Product Change Notification / LIAL-24K0XB344

CCB 4477 Final Notice Implement additional cover tape, carrier tape and plastic reel material supplier for selected Micrel products available in 3L, 5L, 6L and 8L SOT23, 5L and 6L TSOP and 8L SOIC packages at STAR assembly site.

**CCB 4477: Implement additional cover tape, carrier tape and plastic reel material supplier for selected Micrel products available in 3L, 5L, 6L and 8L SOT23, 5L and 6L TSOP and 8L SOIC packages at STAR assembly site.
PCN#: LIAL-24K0XB344**

Cover Tape for SOT23-3/5/6/8L , TSOT-5L/6L

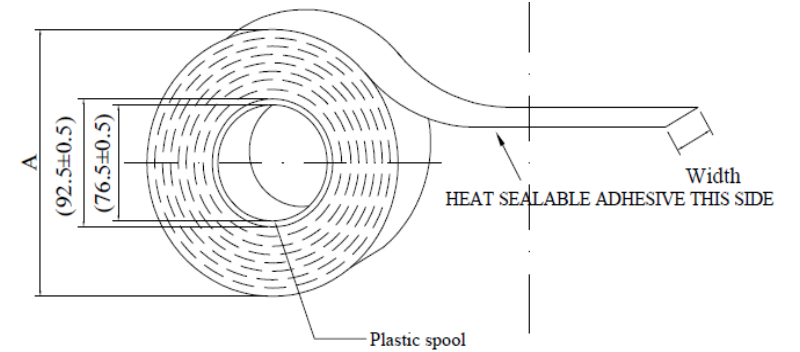
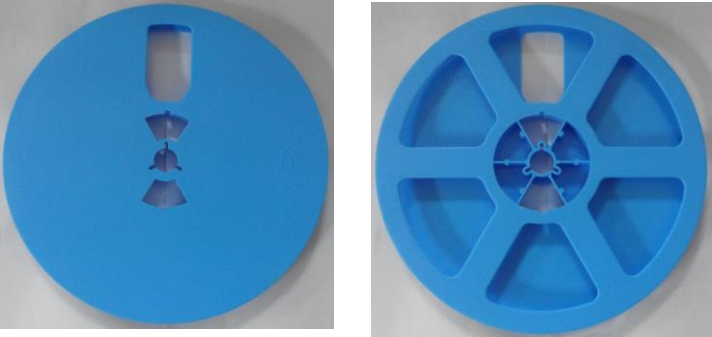
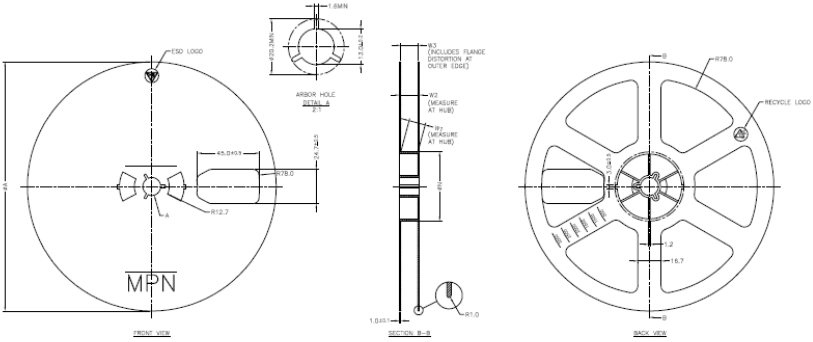
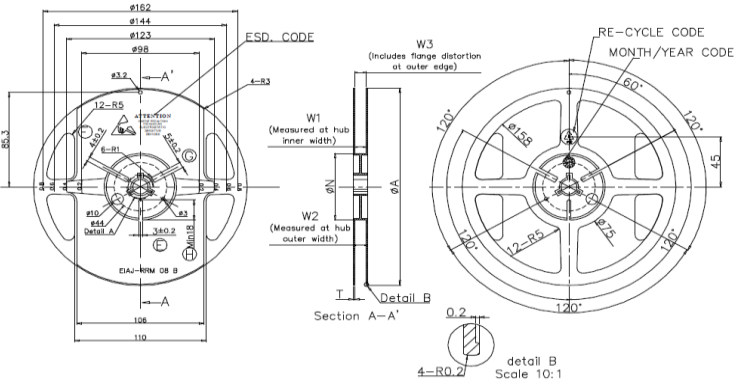
Supplier	Supplier Mfg. part no.	Carrier width (mm)	Cover tape Width "W" (mm)	Thickness (mm)	Sealing Methodology
CPAK	CP38-054A,5.4 mm	8.4	5.4 ± 0.1 mm	0.046 ± 0.010mm	Heat Seal
3M	2675,5.4 mm	8.4	5.4 ± 0.1 mm	0.062 ± 0.013mm	Heat Seal
U-PAK	UP-175-054	8.4	5.4 ± 0.1 mm	0.048 ± 0.050mm	Heat Seal

Carrier Tape for SOIC8L

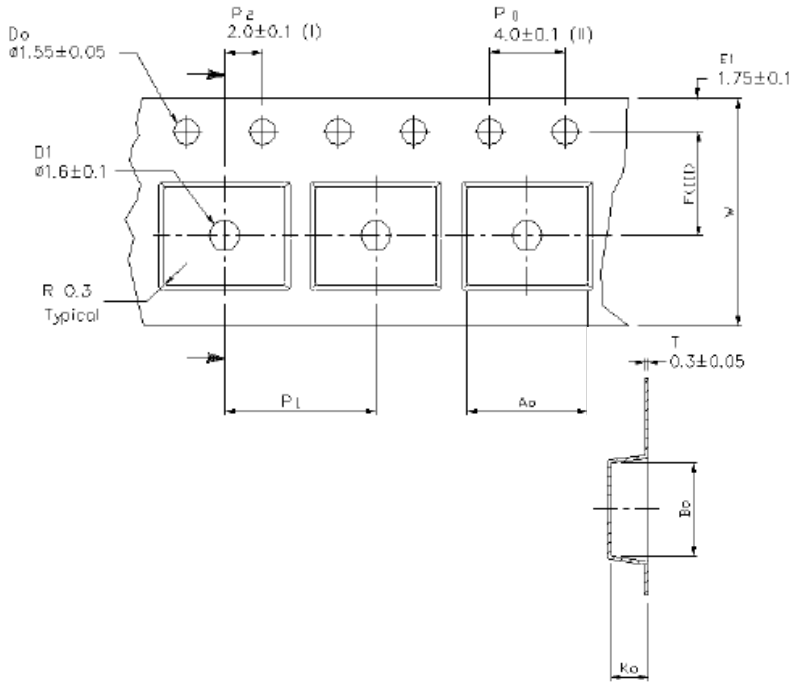
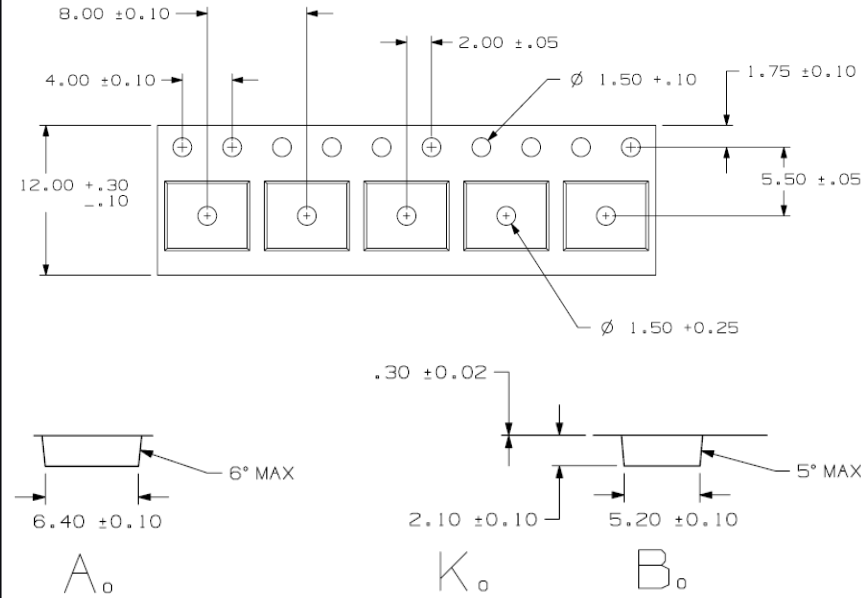
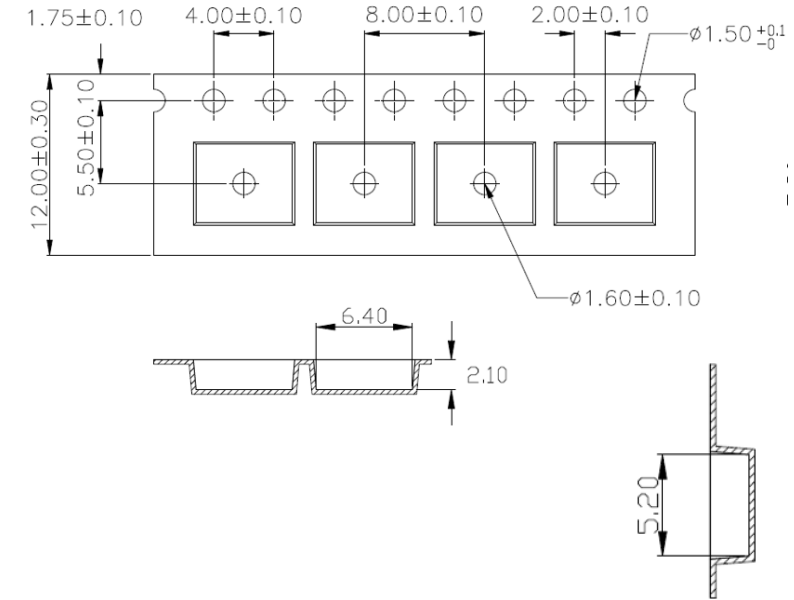
Carrier Tape Supplier	Supplier Mfg. part no.	Width (mm)	Pitch (mm)	A0 (mm)	B0 (mm)	K0 (mm)	Thickness (mm)
CPAK	CPD-092A	12.00 ± 0.100	8.00 ± 0.100	6.40 ± 0.10	5.20 ± 0.10	2.10 ± 0.10	0.30 ± 0.05
3M	TWO13611-4	$12.00 +0.30/-0.10$	8.00 ± 0.100	6.40 ± 0.10	5.20 ± 0.10	2.10 ± 0.10	0.30 ± 0.02
U-PAK	UPKSOIC08A-SMS	12.00 ± 0.100	8.00 ± 0.100	6.40 ± 0.10	5.20 ± 0.10	2.10 ± 0.10	0.30 ± 0.05

Cover Tape for SOIC8L

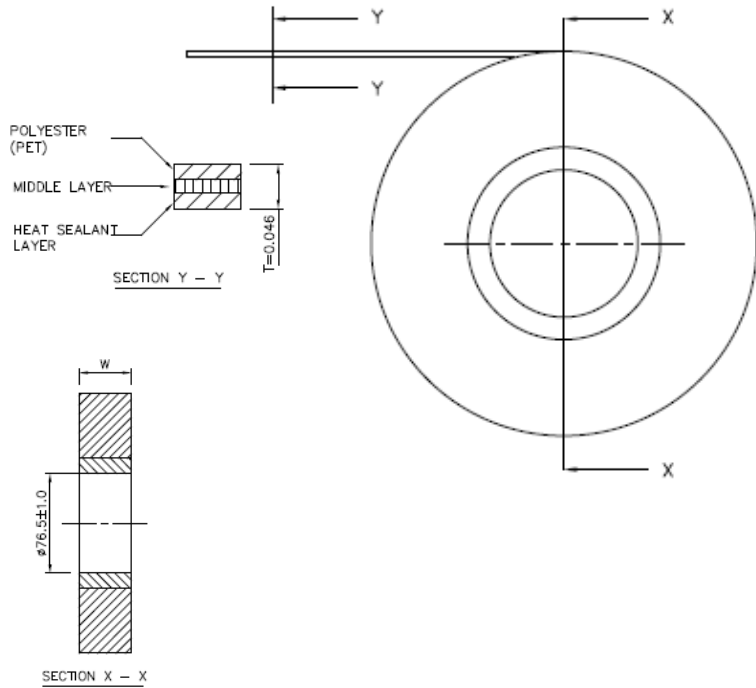
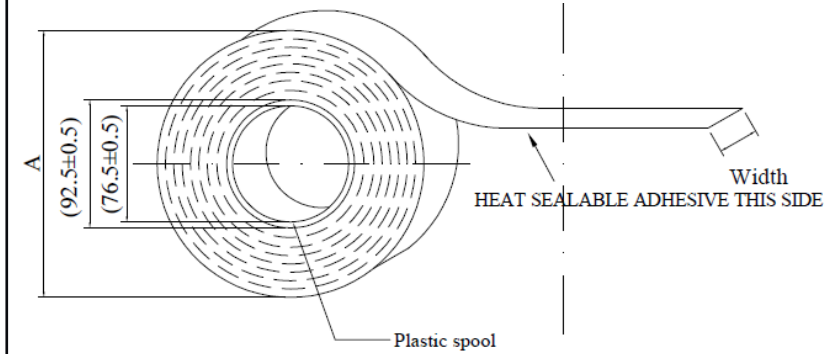
Supplier	Supplier Mfg. part no.	Carrier width (mm)	Cover tape Width "W" (mm)	Thickness (mm)	Sealing Methodology
CPAK	CP38-054A, 5.4 mm	12	9.2 ± 0.1 mm	0.056 ± 0.005mm	Heat Seal
3M	2675, 9.3 mm	12	9.3 ± 0.1 mm	0.062 ± 0.013mm	Heat Seal
U-PAK	UP-175-093	12	9.3 ± 0.1 mm	0.048 ± 0.050mm	Heat Seal
